Technical Report

Summary and Analysis of Comments
Received in Response to Draft EPA Procedures
for the Measurement of Tire Rolling Resistance and
Subsequent Grading and Labeling of Tires

Glenn D. Thompson

July 1980

FIGURE 1

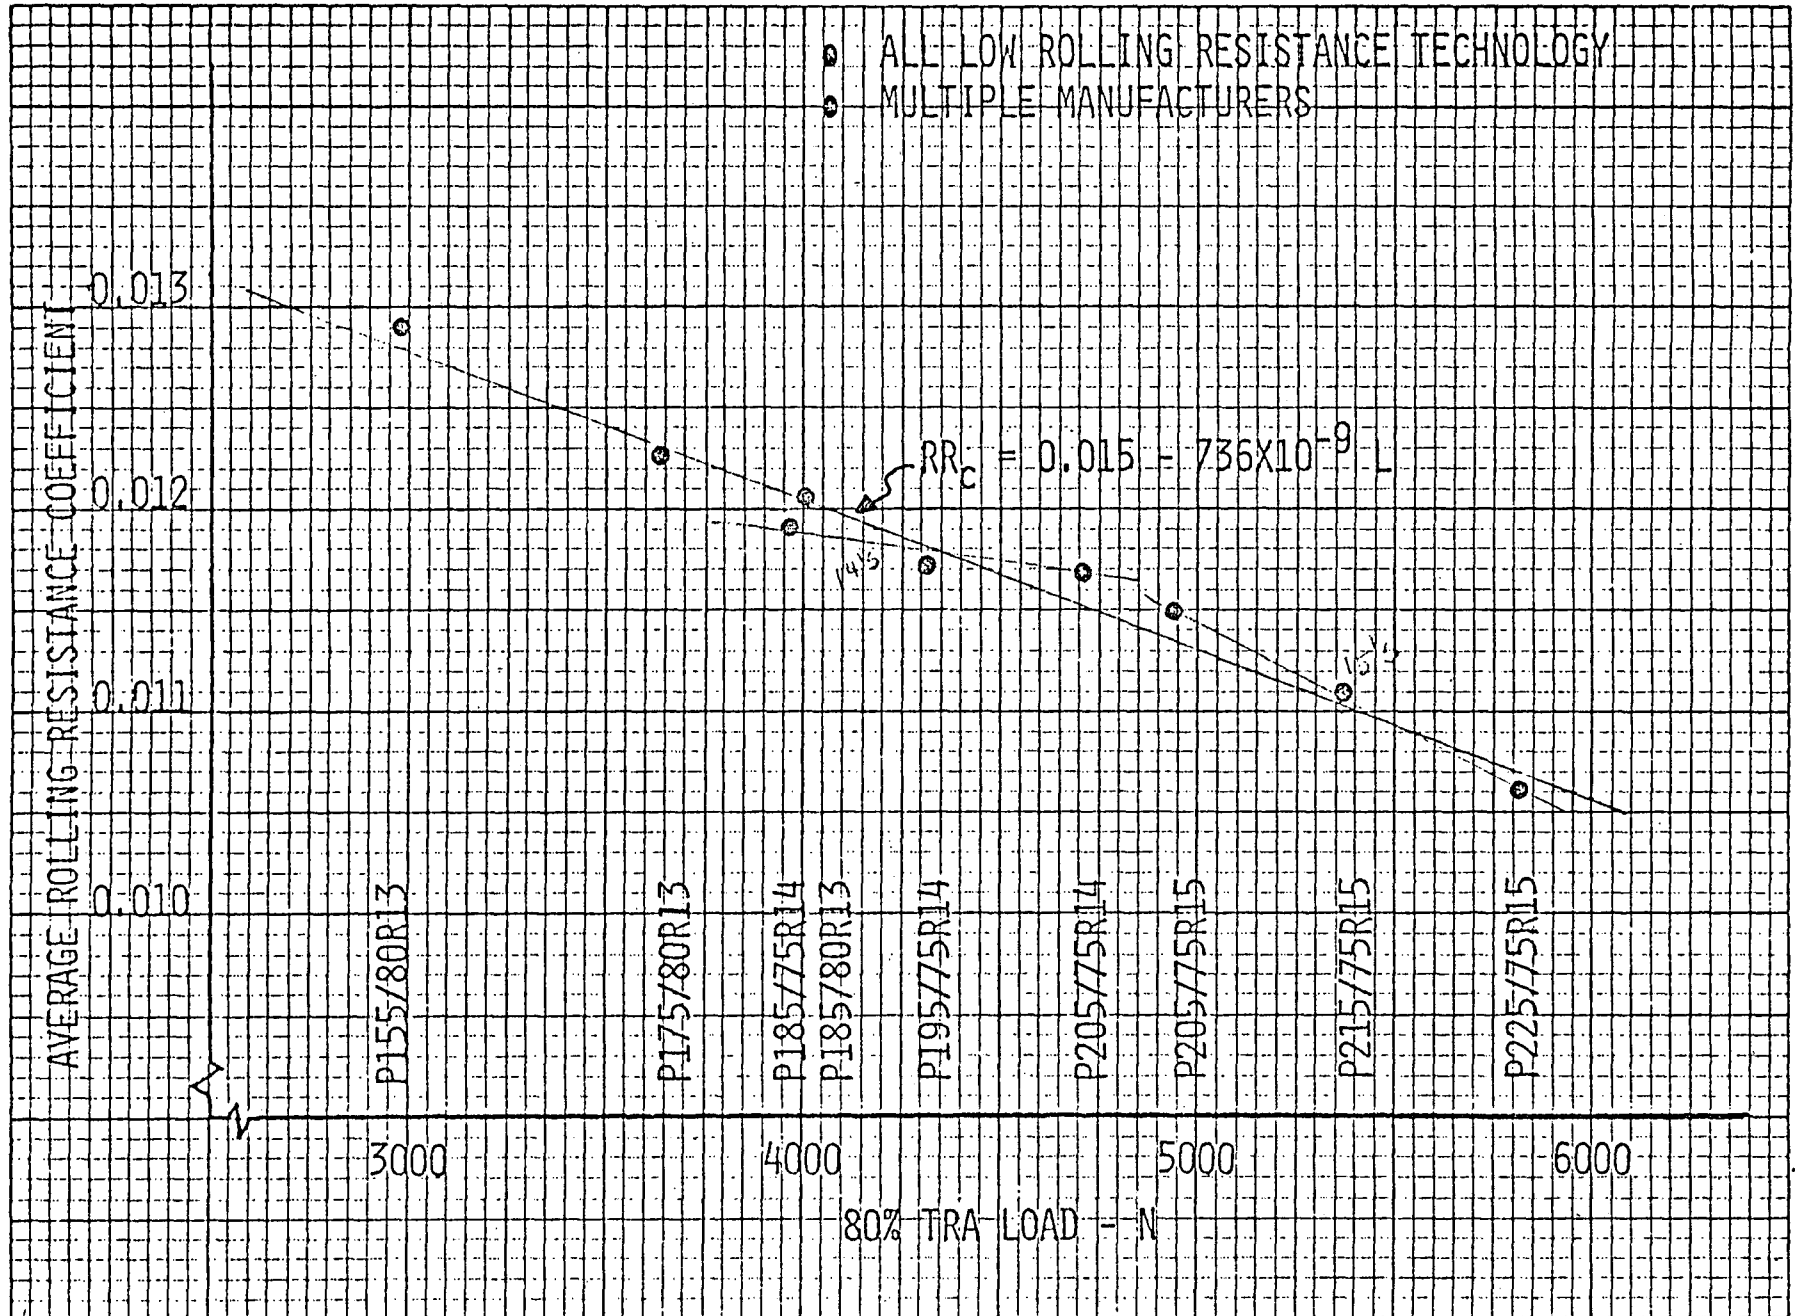
We believe the principal intent of the tire fuel economy grading system is to encourage the development of lower rolling resistance tires and to accurately inform the aftermarket buyer of the relative fuel efficiency levels of different tire lines. The test data in Figure 1.(attached) indicates that there is a size relationship to rolling resistance coefficients such that smaller tire sizes have a higher rolling resistance coefficient than larger sizes, even though

they represent the same level of tire technology. Our analysis of this range of tires indicates that a full size line of equal technology tires would have as many as three different fuel economy ratings (i.e., A, B, and C). We feel this would lead to considerable confusion in the customer's mind, especially since some of the smaller size tires may not be capable of reaching a grade "A" level with today's best known technology. We would propose that an alternate criteria be considered. This criteria would encompass the inherent slope of the curve shown in Figure 1. The proposal would be to calculate an index that would be dependent on both the rated load and the upper limit on RR_c as described in the EPA proposed method.

Since the average trend (Figure 1) can be described by a best fit linear relationship in the form

We would expect this trend to be valid over the range of tires shown in Figure 1. If one assumes that the 90% confidence/90% population limits have the same trend, then this equation would be:

There is merit in the concept of the GM proposal to attempt to make tire grades independent of tire size. Primarily, it is generally accepted that it is more difficult to manufacture low rolling resistance tires in small sizes. Consequently a given brand or design of tire might, under the current classification system, be a "grade B" tire in larger sizes yet only be a "grade C" tire in the smaller sizes. This would be a technically correct statement of the rolling resistance coefficient of the tire, but might cause some consumer confusion and diminish use of the system. Likewise this could prevent a general tire line from being advertised as "rolling resistance grade A tires" and therefore, reduce dissemination of the rolling resistance grade information in tire advertising. •

There are, however distinct problems with the GM proposal. If the "adjustment factor" for tire size is determined and included in the EPA Recommended Practice then this single "fixed" value may not be appropriate for all tire technologies. If the adjustment factor is to be determined for each tire design, then the grade could become very dependent on the particular tires selected to determine this factor. In general, the logic of a floating adjustment factor is circuitous since the data obtained from the tests of diverse tires would be used to determine an adjustment factor based on the apriori decision that the tires tested were of equivalent design-technology, where as the purpose of the testing should be to determine or verify the rolling resistance technology of the tire.

It is recommended that a grading system which provides some adjustment for the tendency of smaller tires to have higher rolling resistance coefficients be developed. This system should be based on a predetermined or "fixed" adjustment factor. However, since GM was the only commenter suggesting such an approach, the proposed system should be distributed for comments before final adoption.
